ACCESSIBILITY ASSESSMENT

February 24, 2025

ADA TITLE II ASSESSMENT

Thurston Elementary School

Assembly	Exterior Access Route
Type	Exterior Accessible Route
ADA Standard	403.3
Barrier Detail	The accessible route has cross slopes greater than 1:50 (2%).
Location Description	Accessible Pathway between Site Entrance D-4 to Street
Observed	Feb 6, 2025 by Thomas.chiarella@bureauveritas.com

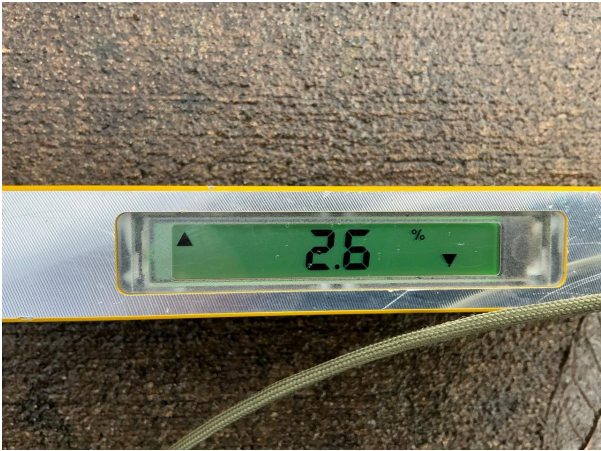
Sidewalk sections on accessible route has cross slopes of 2.6%. (One section, 6-1/2' x 19')

The walkway should be graded to a maximum 1:50 (2%) cross slope. An accessible route has maximum 1:20 (5%) running slope and maximum 1:50 (2%) cross slope. [EXCEPTION: Cross slopes not exceeding 1:48 (2.08%) are permitted.] The clear width of walking surfaces shall be 36" minimum. [EXCEPTION: The clear width shall be permitted to be reduced to 32" minimum for a length of 24" maximum provided that reduced width segments are separated by segments that are 48" long minimum and 36" wide minimum.] Where grading to maximum running slope of 1:20 (5% running slope) is not possible, provide a compliant ramped surface within the walkway with maximum slope 1:12 (8.33%) and maximum ramp run rise of 6" without handrails. If a ramped surface with running slopes greater than 1:20 (5%) and maximum 1:12 (8.33%) rises more than 6", handrails are required. The cost estimate for this barrier removal is based on grading the running slope to maximum 1:20 (5%). The quantity and order of magnitude cost estimate provided for this barrier are limited to the extent of the area identified as non-compliant. Additional costs that may be associated with removal of the barrier are not included.

Photos for Barrier ID: AX563285

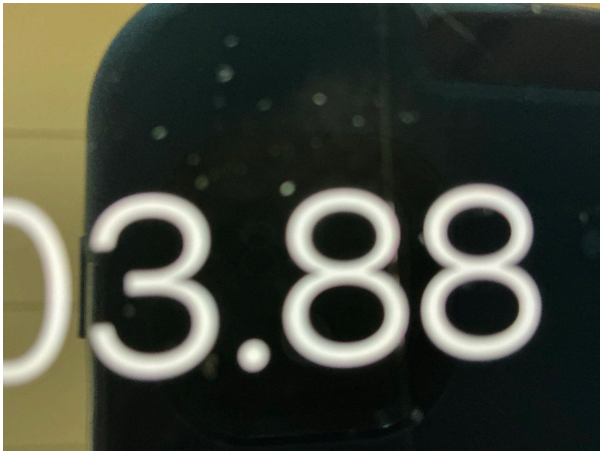
Assembly	Entrance to Building	
Type	Building Entrance - Door	
ADA Standard	404.2.8	
Barrier Detail		
The accessible door with door closer has a sweep period of less than 5 seconds from 90 degrees to a position 12 degrees from latch.		
Location Description	Door D-6 West	
Observed	Feb 6, 2025 by Thomas.chiarella@bureauveritas.com	
Site Conditions		
The accessible door with door closer has a sweep period of 3.88 seconds from 90 degrees to a position 12 degrees from latch.		
Resolution		
Adjust closer or remove and replace closer to ensure that the door has a closure time of at least 5 seconds within 12 degrees of the latch. Door closers and gate closers shall be adjusted so that from an open position of 90 degrees, the time required to move the door to a position of 12 degrees from the latch is 5 seconds minimum.		
Quantity	Unit Cost	Total Cost
1 EA	631.35	\$ 631
Priority	1

Photos for Barrier ID: AX563288

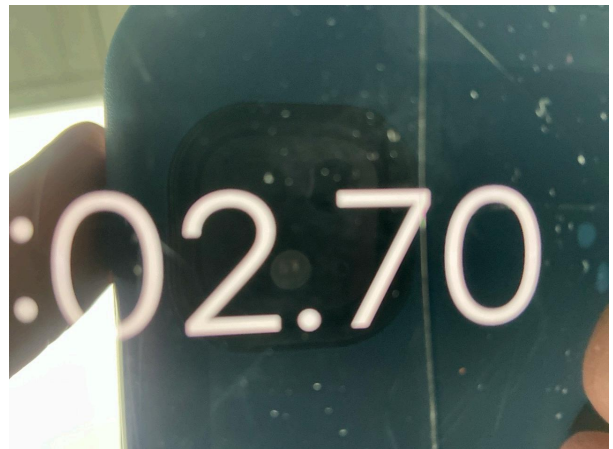
Assembly	Entrance to Building	
Type	Building Entrance - Door	
ADA Standard	404.2.8	
Barrier Detail		
The accessible door with door closer has a sweep period of less than 5 seconds from 90 degrees to a position 12 degrees from latch.		
Location Description	Door D-8 Southwest, 2nd Floor	
Observed	Feb 6, 2025 by Thomas.chiarella@bureauveritas.com	
Site Conditions		
The accessible door with door closer has a sweep period of 2.70 seconds from 90 degrees to a position 12 degrees from latch.		
Resolution		
Adjust closer or remove and replace closer to ensure that the door has a closure time of at least 5 seconds within 12 degrees of the latch. Door closers and gate closers shall be adjusted so that from an open position of 90 degrees, the time required to move the door to a position of 12 degrees from the latch is 5 seconds minimum.		
Quantity	Unit Cost	Total Cost
1 EA	631.35	\$ 631
Priority	1

Photos for Barrier ID: AX563293

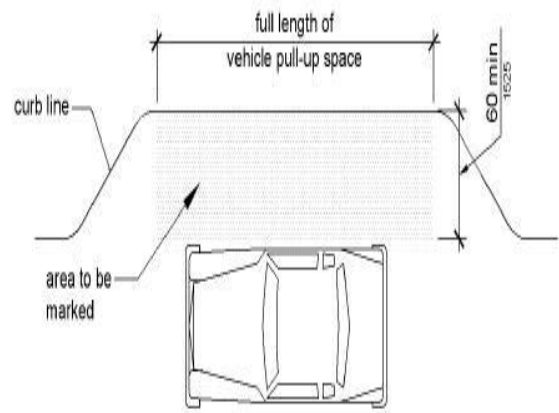
Assembly	Exterior Access Route	
Type	Loading/Unloading Zone	
ADA Standard	209, 503	
Barrier Detail		
An accessible passenger loading/unloading zone is not provided where a loading/unloading area is present.		
Location Description	Loading/Unloading Zone	
Observed	Feb 6, 2025 by Thomas.chiarella@bureauveritas.com	
Site Conditions	An accessible loading/unloading zone is not provided.	
Resolution		
Provide an accessible passenger loading/unloading zone. Passenger loading zones shall provide at least one accessible passenger loading zone in every continuous 100 linear feet of loading zone space, or fraction thereof, except bus loading areas. At least one accessible passenger loading zone shall be provided at an accessible entrance to a licensed medical care or licensed long term care facility where the period of stay exceeds 24 hours. The vehicular pull-up space shall be 96 inches wide minimum and 20 feet long minimum. The loading/unloading zone should allow the access aisle to be at the same level as the loading/unloading area it serves. The access aisle should be marked and separate from the loading/unloading area it serves. The access aisle shall be 60 inches wide minimum. Access aisles shall extend the full length of the vehicle pull-up spaces they serve. Access aisles shall be marked so as to discourage parking in them. Vehicle pull-up spaces and access aisles serving them shall comply. Access aisles shall be at the same level as the vehicle pull-up space they serve. Changes in level are not permitted. [EXCEPTION: Slopes not steeper than 1:48 (2.08%) shall be permitted.] Vehicle pull-up spaces, access aisles serving them, and a vehicular route from an entrance to the passenger loading zone, and from the passenger loading zone to a vehicular exit shall provide vertical clearance of 114 inches minimum.

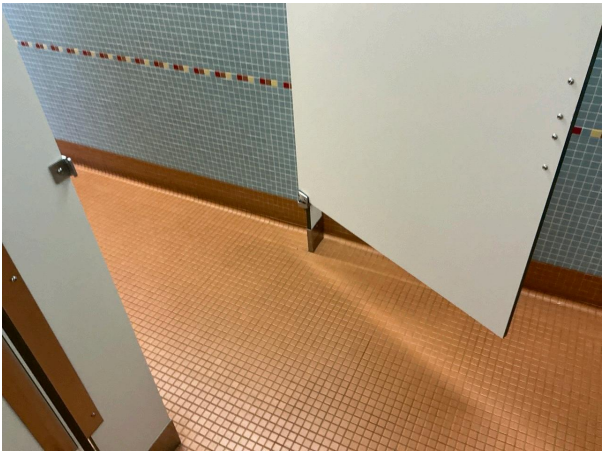
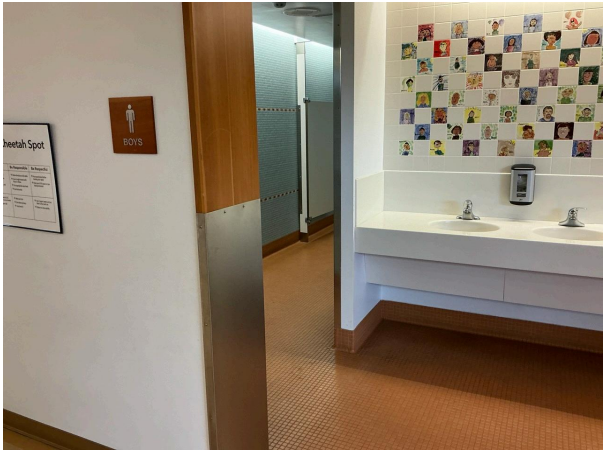
Assembly	Restroom
Type	Restroom/Bathroom-Door
ADA Standard	309, 404.2.7, 604.8.1.2
Barrier Detail	The hardware at the wheelchair stall door is not compliant.
Location Description	Boys Muluser Restroom, 2nd Floor
Observed	Feb 6, 2025 by Thomas.chiarella@bureauveritas.com

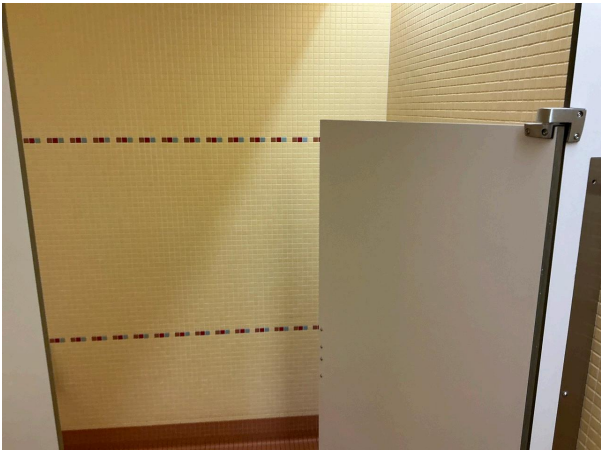
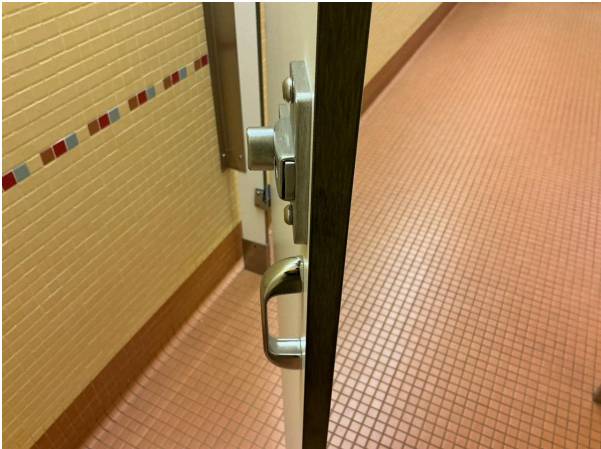
Assembly	Restroom
Type	Restroom/Bathroom-Door
ADA Standard	309, 404.2.7, 604.8.1.2
Barrier Detail	The hardware at the wheelchair stall door is not compliant.
Location Description	Girl's Restroom, North Hallway
Observed	Feb 6, 2025 by Thomas.chiarella@bureauveritas.com

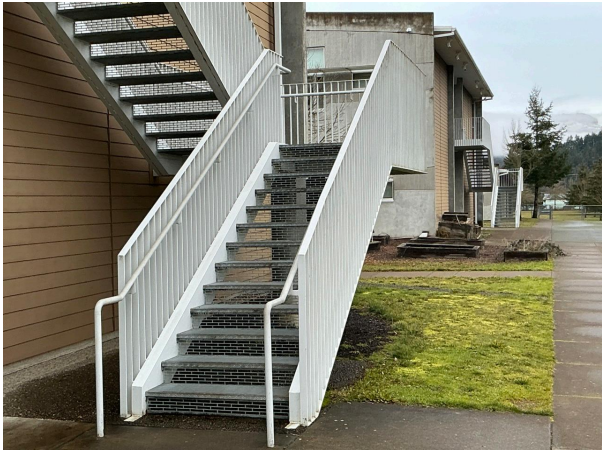
Assembly	Exterior Access Route	
Type	Stairs	
ADA Standard	2009 ANSI A117.1-504.5.1	
Barrier Detail		
OREGON: The stair treads do not have visual contrast of dark-on-light or light-on-dark on the leading 2" of the tread from the remaining portion of the tread surface.		
Location Description	Stair ST-3 and ST-4 (East Side)	
Observed	Feb 6, 2025 by Thomas.chiarella@bureauveritas.com	
Site Conditions		
The stair treads do not have visual contrast of dark-on-light or light-on-dark on the leading 2" of the tread from the remaining portion of the tread surface.		
Resolution		
Provide light-on-dark or dark-on-light visual contrast on the leading 2" of each tread, in contrast with the remaining portion of the tread surface.		
Quantity	Unit Cost	Total Cost
52 EA	60.72	\$ 3,157
Priority	3
